Office Action Summary	Application No. 10/573,011	Applicant(s) HASSDENTEUFEL ET AL.	
	Examiner Tho v. Duong	Art Unit 3744

DETAILED ACTION

Figure A: The modified figure corresponds to figure 5 with limitations shown.

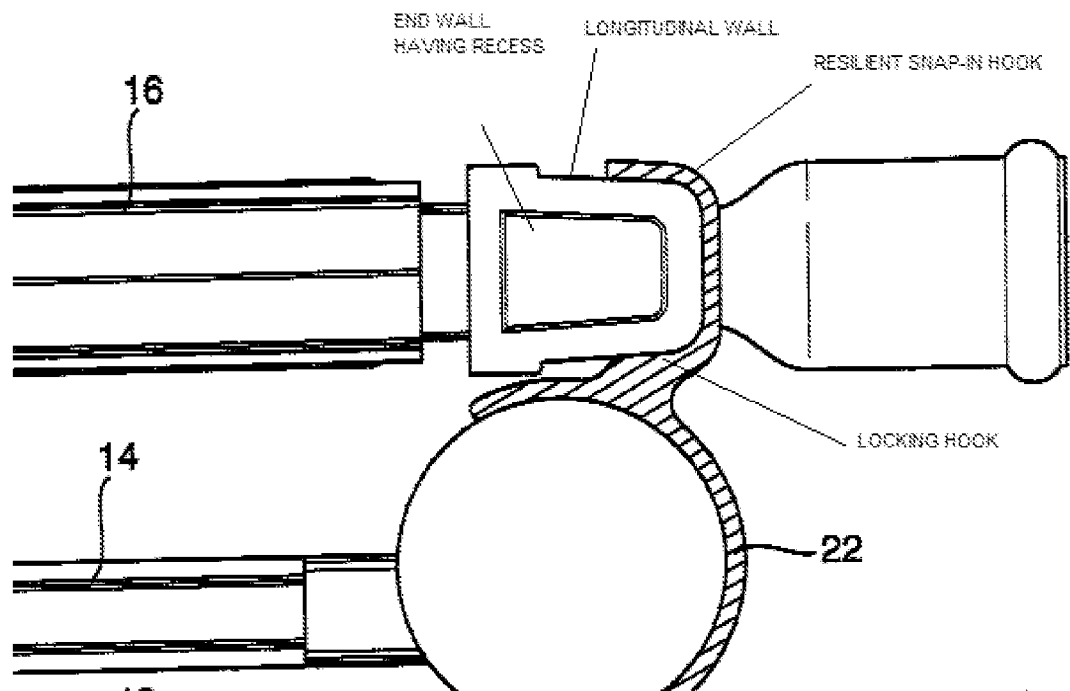
Claims 1,5-8,21 and 26 are rejected under 35 U.S.C. 102(b) as being anticipated by Rawley et al. (GB 2373571A). Rawley discloses (figures 1-6 and figure A as shown below) a heat exchanger module as claimed. Rawley further discloses (figure 1) the header tanks comprises necks (inlet and outlet connections) and the module supports comprises cutouts which surround the necks; and the module supports comprises fastning openings (42) on their upper end faces. Regarding claim 6 and 26, Rawley discloses (figures 1-2) the longitudinal side faces of the

Figure B: The modified figure corresponding to figure 3 with limitation shown

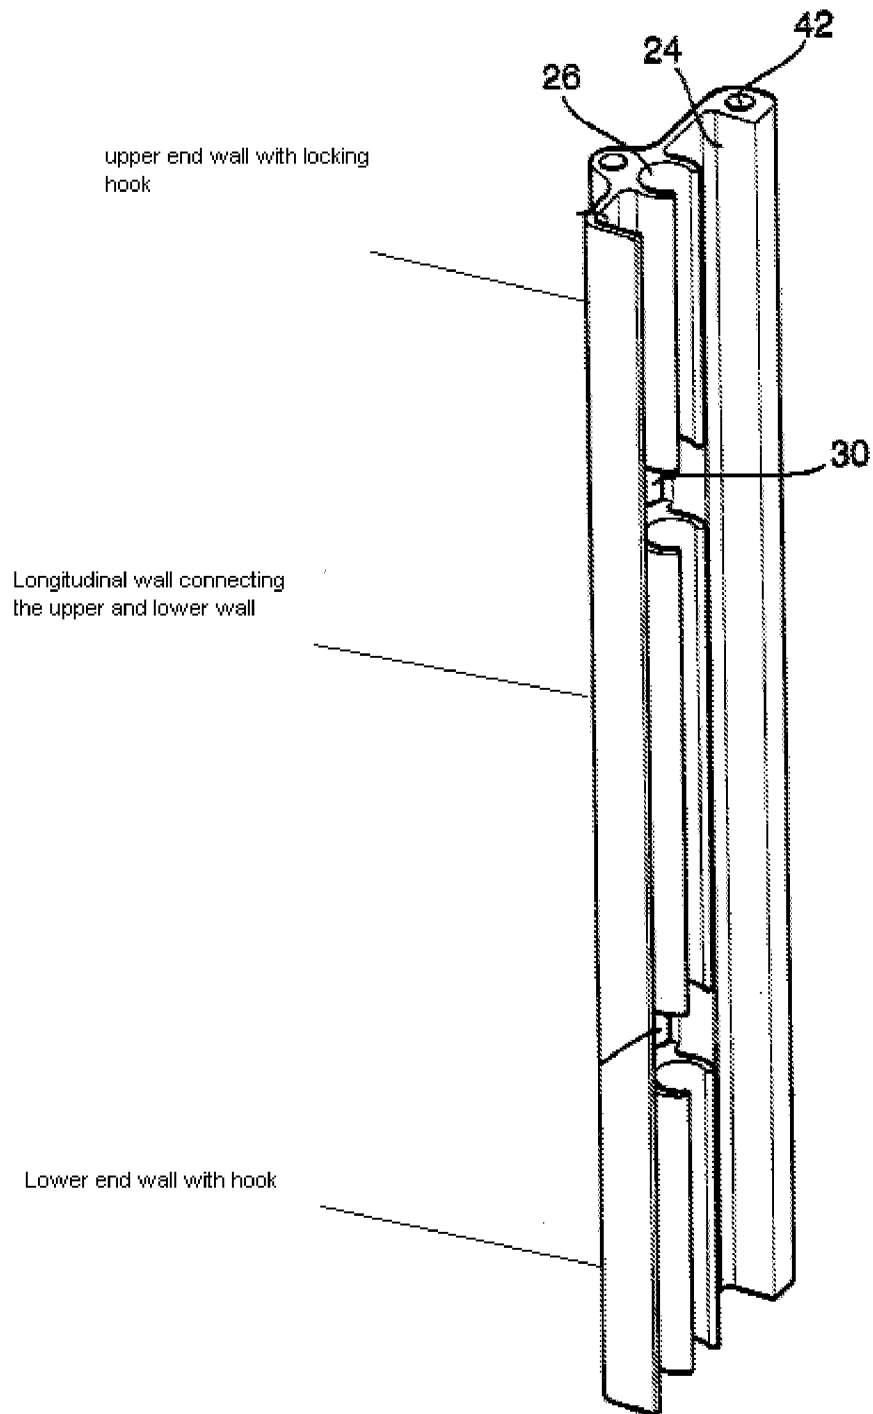
header tanks project beyond the recessed end walls forming a latching surface or stop surface on the longitudinal wall of the header tank so that the hook arrangements engage with the latching surface or stop surface. Rawley further discloses (figure B shown bellow) that each module support (20) has a lower end wall, an upper end wall and a longitudinal wall connecting the upper and lower end walls, wherein the hooks are attached to one of the end wall respectively. Regarding claim 7, the method of forming the device is not germane to the issue of the patentability of the device itself. "Even though product-by-process claims are limited by and defined by the process, determination of patentability is based on the product itself. The patentability of a product does not depend on its method of production. If the product in the product-by-process claim is the same as or obvious from a product of the prior art, the claim is unpatentable even though the prior product was made by a different process." *In re Thorpe*, 777 F.2d 695, 698, 227 USPQ 964, 966 (Fed. Cir. 1985). In this instant case, the heat resilient snap hook engaging with the stop face in the product-by-process claim is the same as or obvious from the resilient snap hook engaging with the stop faces of Rawlye, the claim is unpatentable even though the prior product was made by a different process.
